ATTACHMENT 3

PROPOSED TECHNICAL SPECIFICATION

Marked-up Technical Specifications Pages,

TABLE 4.3 (Continued)

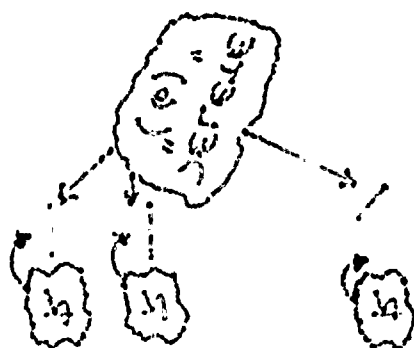
Handwritten notes and a central instruction:

- Arrows point from the handwritten "R (6)" notes to a central box labeled "DELETE '(6)'"
- The "R (6)" notes are located next to the Channel Calibration entries for items d and e.

~~(6) CHANNEL CALIBRATION frequency shall be at least once per 18 months.~~
